ADDENDUM #01

ADA Compliance Upgrades Foussat and Libby

BID NO. 2025-21-070B

RFI #1: DWG Review - ADA Scope

C1.2

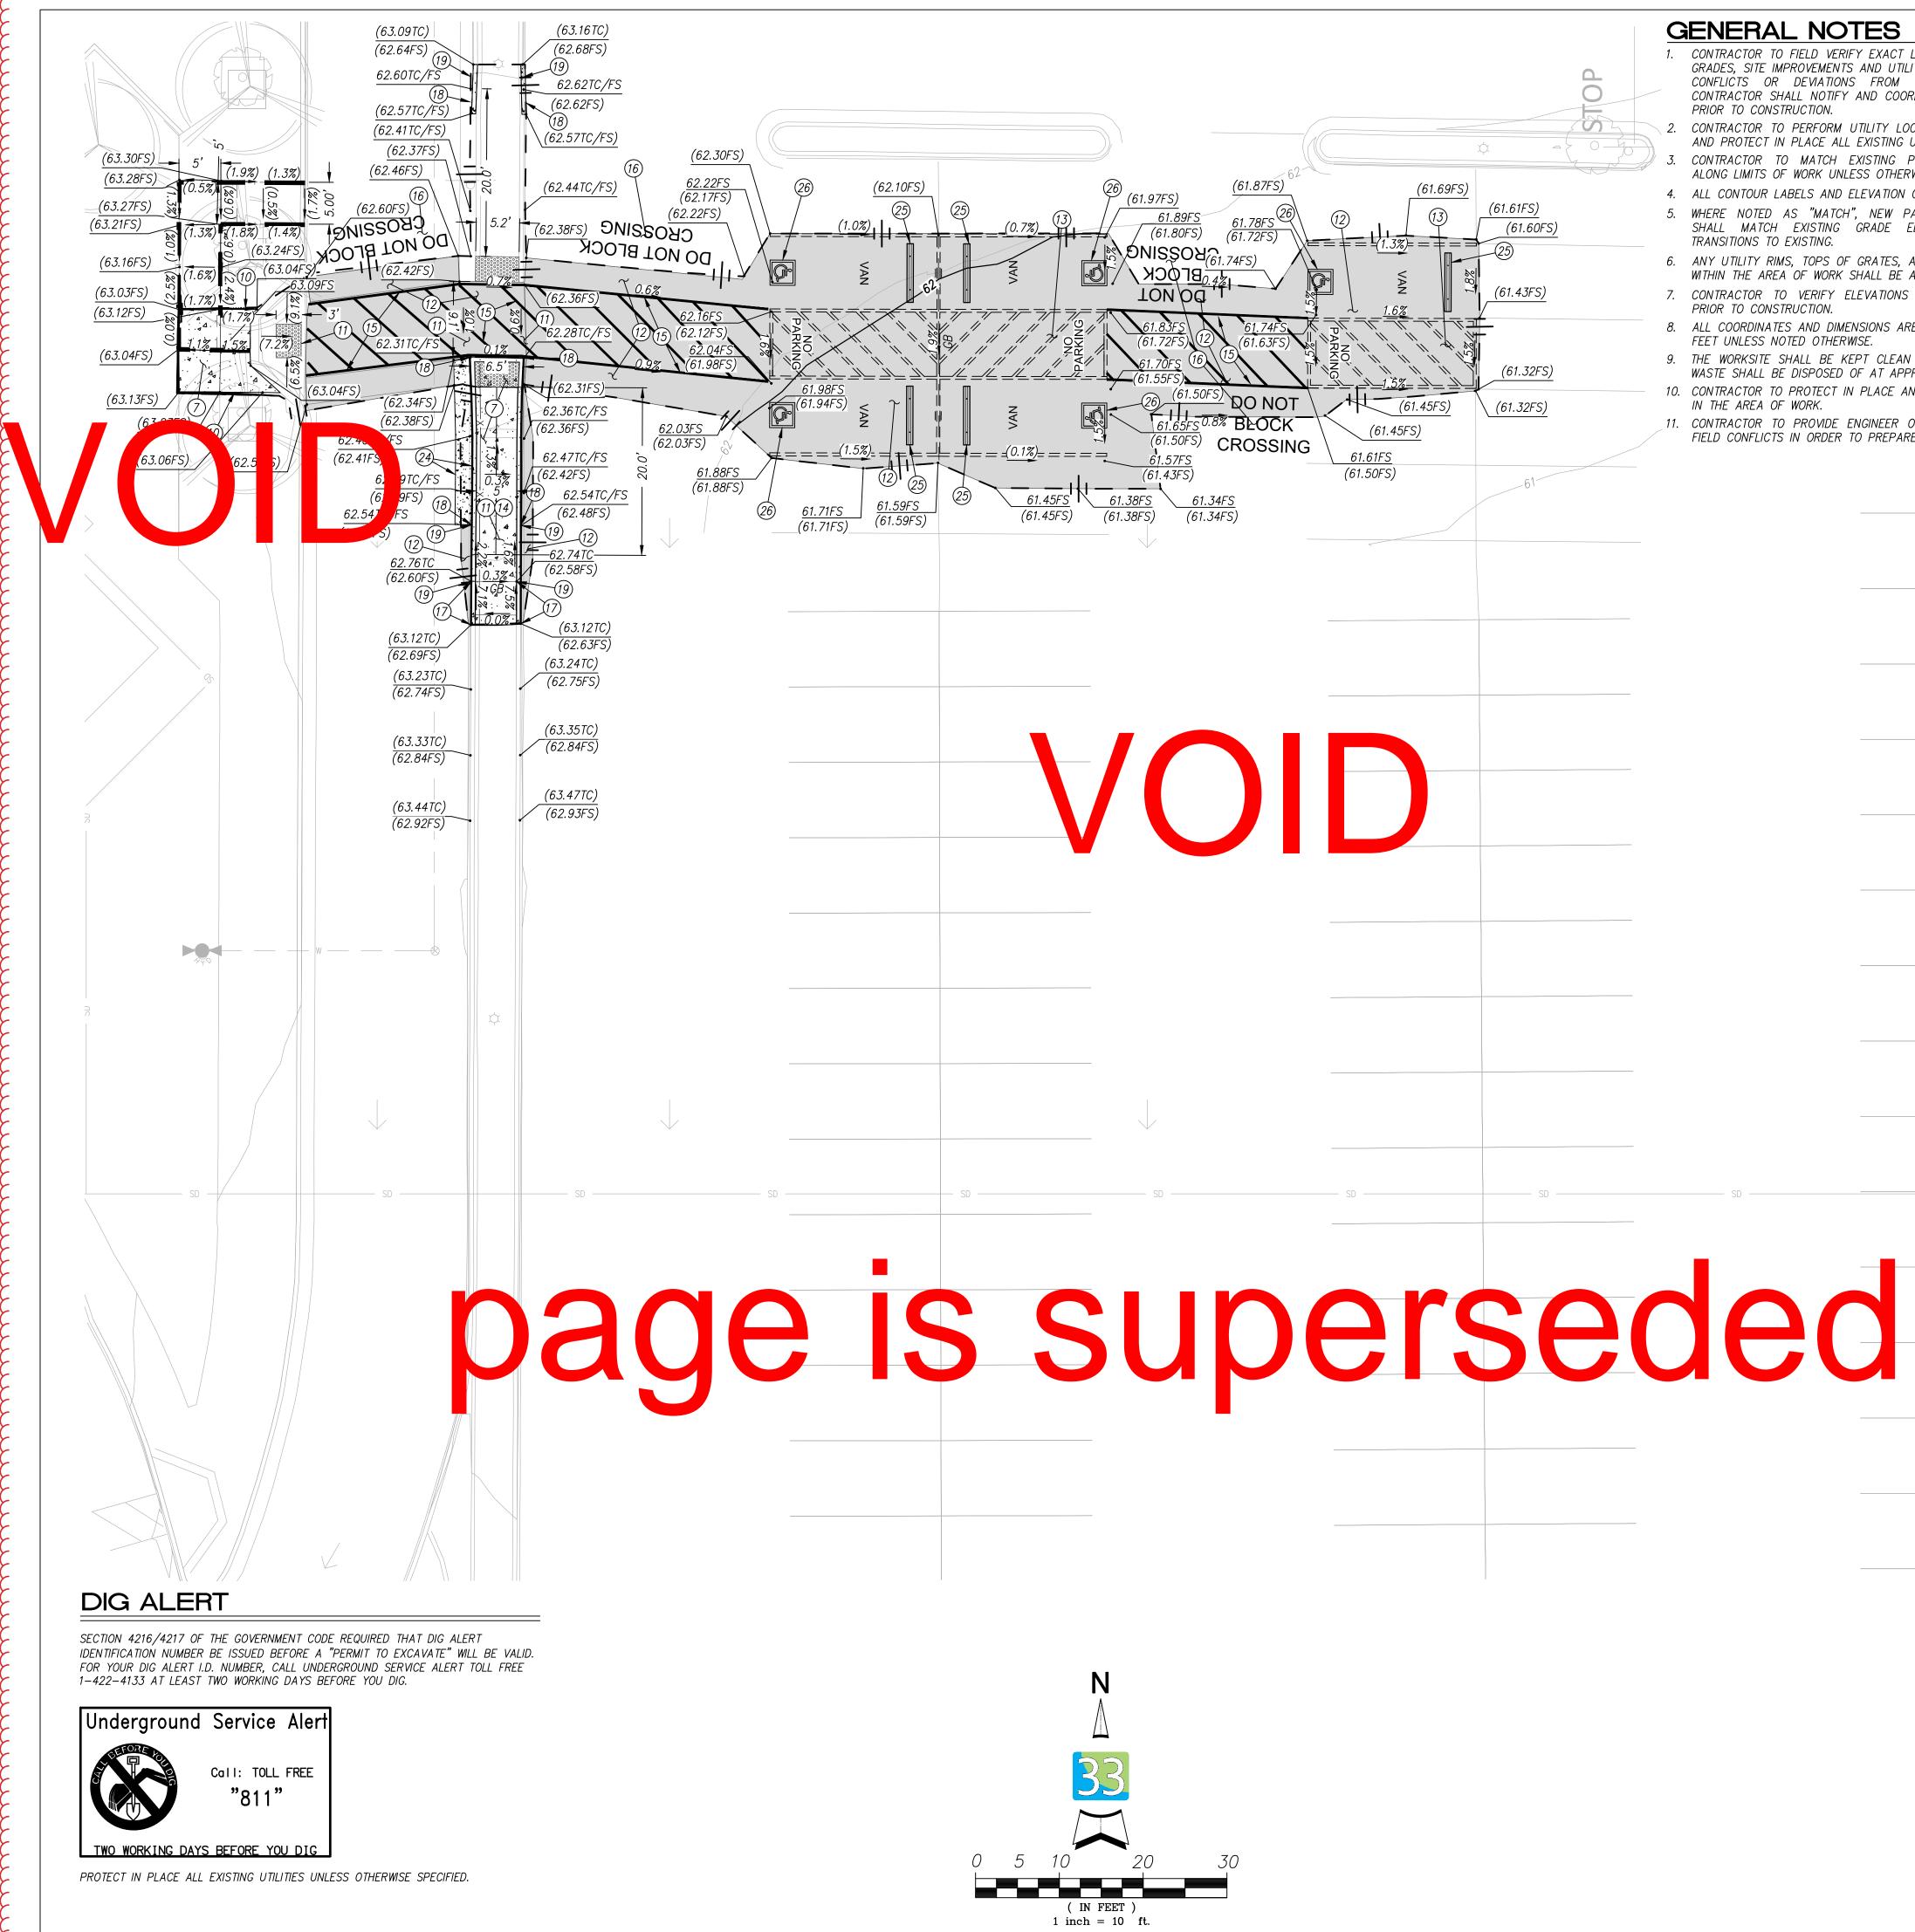
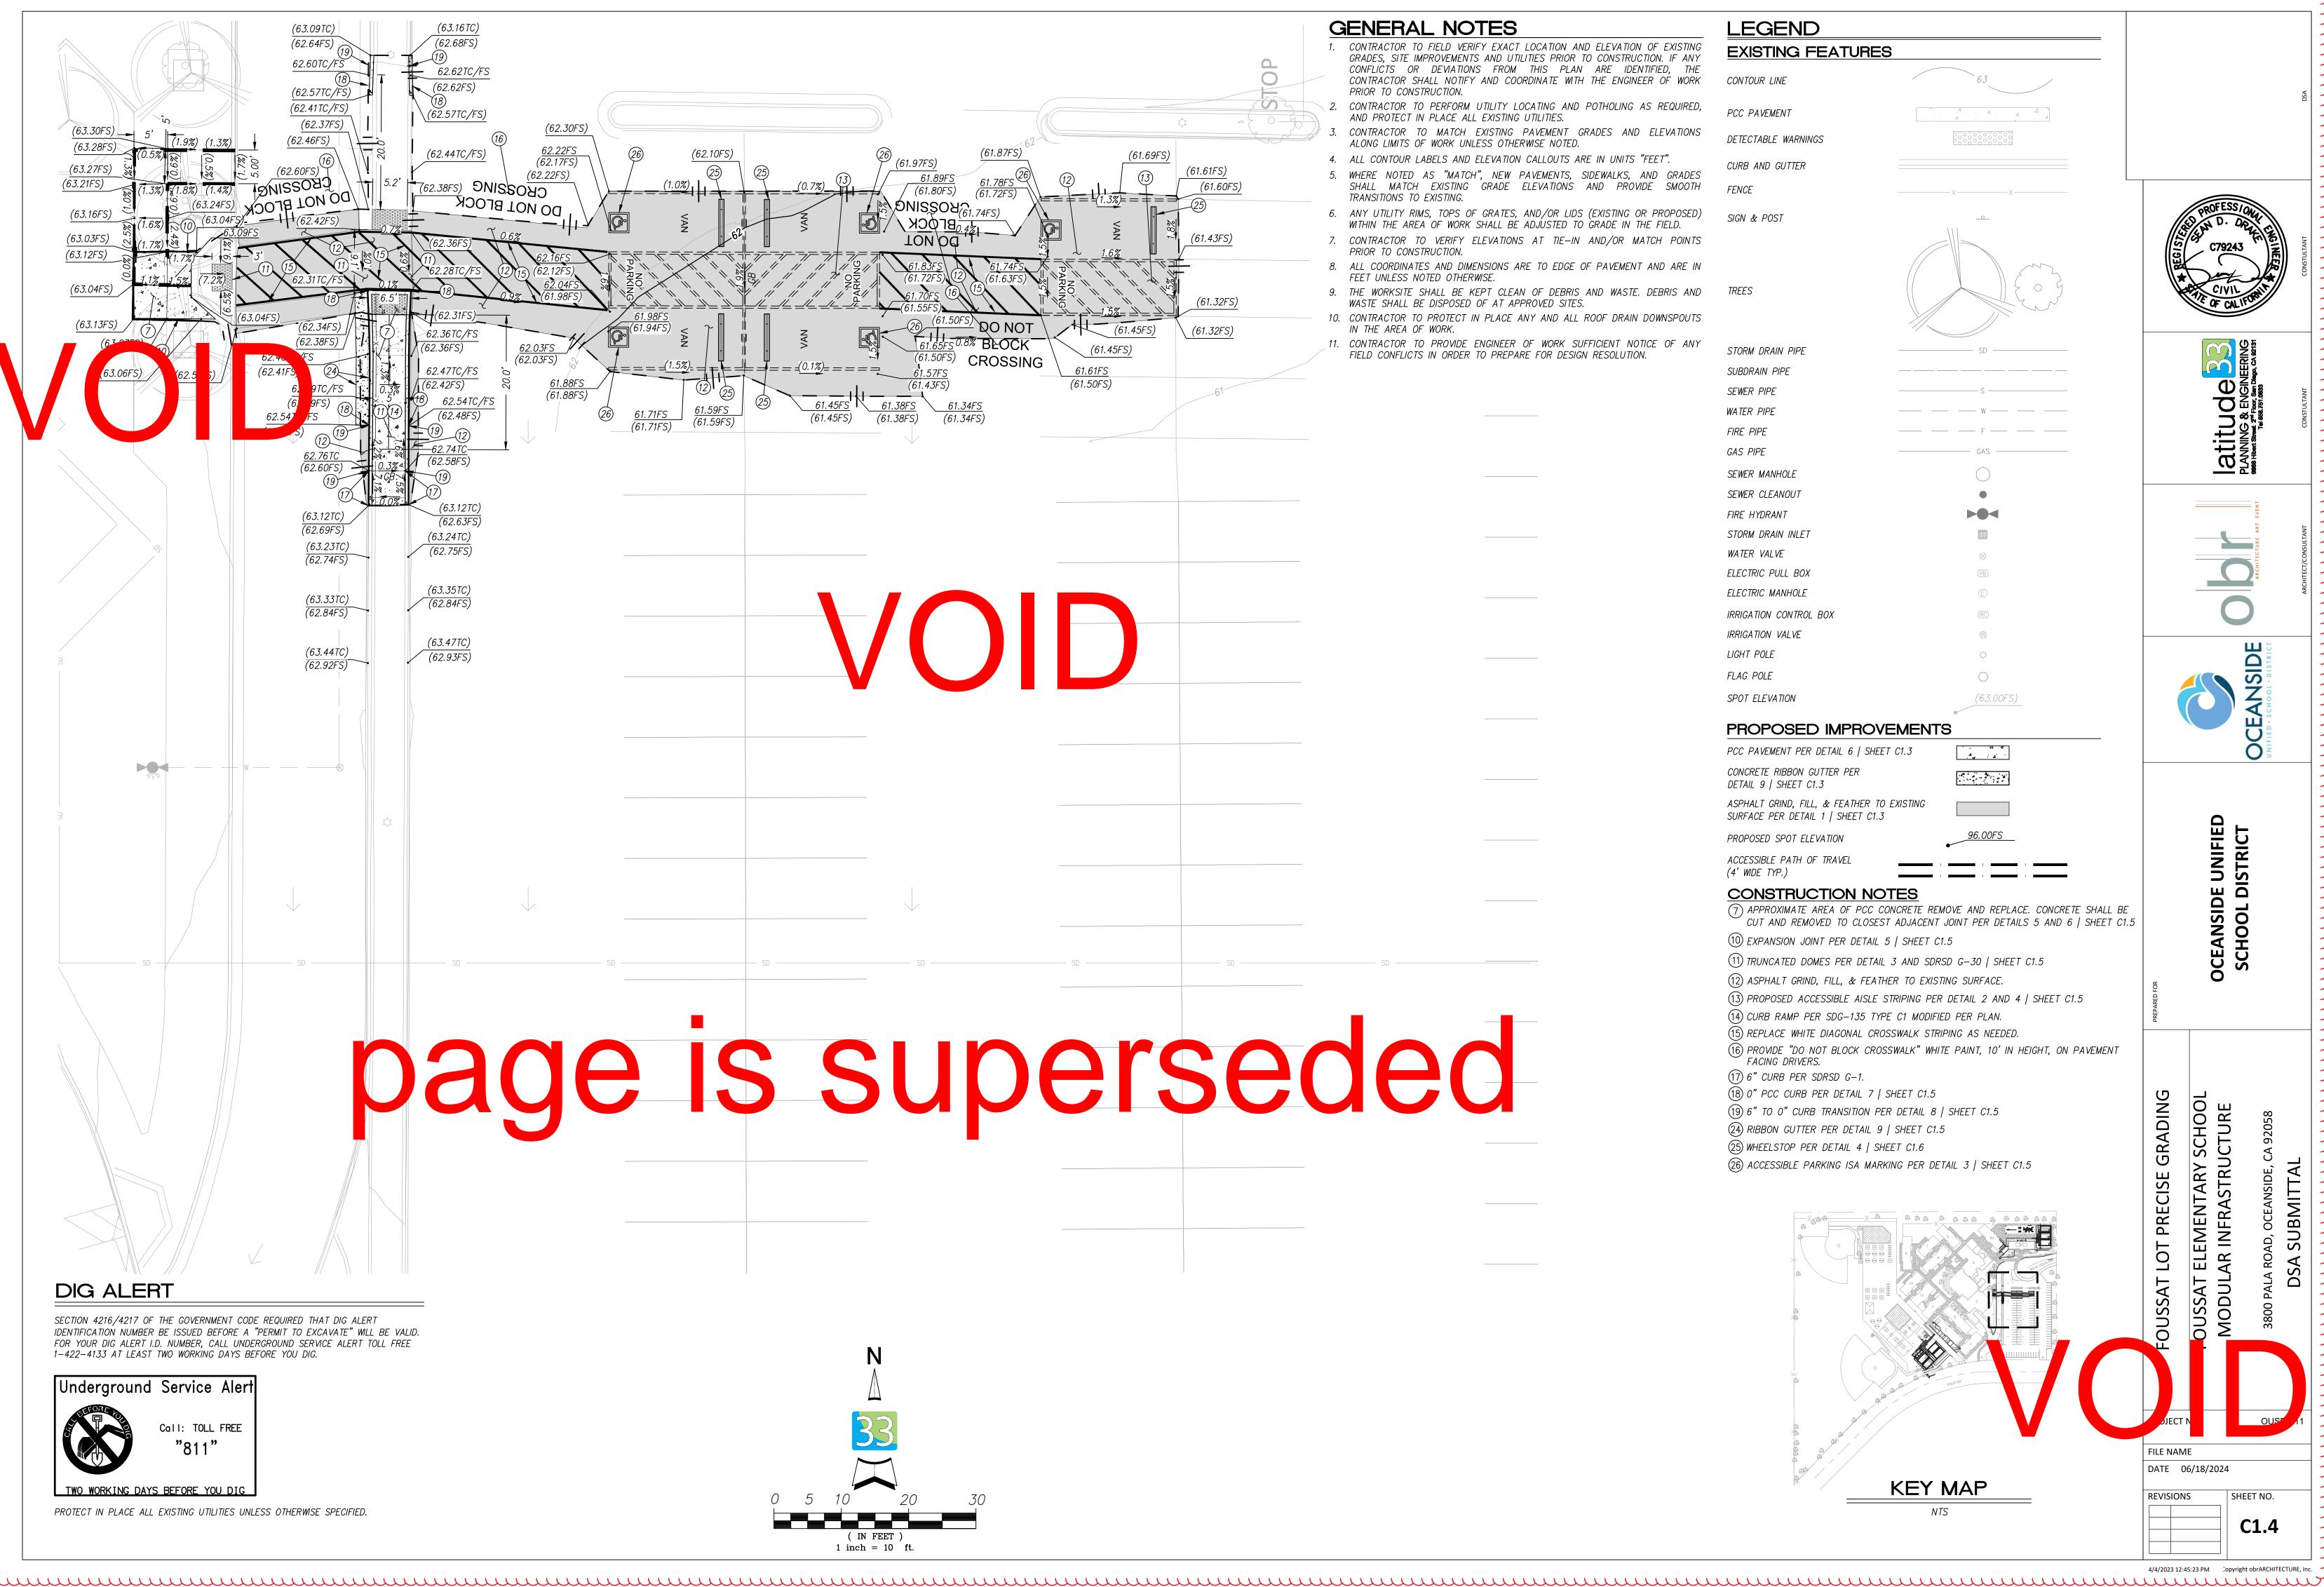
Sheet - C1.4 is now C1.2: I have some dimensions and highlights for the areas in question.

- The images show that we do not have 5' of sidewalk on either side of the sidewalk due to the existing fence. Please clarify if 5' is a minimum requirement for the sidewalk. (This will help me determine the scope needed for the existing fence at both sides.) DSA instructed us that the dimension of the sidewalk is from inside face of fence to outside face of curb (we can include the curb in the dimension!) so I think we are ok.

- 2. There appears to be a space between where the truncated domes were needed vs where the sidewalk striping starts. Please clarify if there is a minimum amount of spacing between the asphalt striping and sidewalk striping. You will see that one of the sidewalks already has striping that is 20' but that is dependent on the existing spacing shown. Please note, if there is a clearance requirement to obtain the 20', I may run into conflicts with the existing light post. The plans contemplate removal and replacement of portion of the curb and place a transition curb on the north side drop off, which will in fact be close to the light post.

- 3. Please clarify if you want the opposite side of the pathway that does not have striping to mirror the sidewalk that already has striping. I have 3 options available on

the attached C1.4 AKA C1.2 for your input. If I am understanding correctly, the sidewalk, curb, and painting should mirror the existing side.
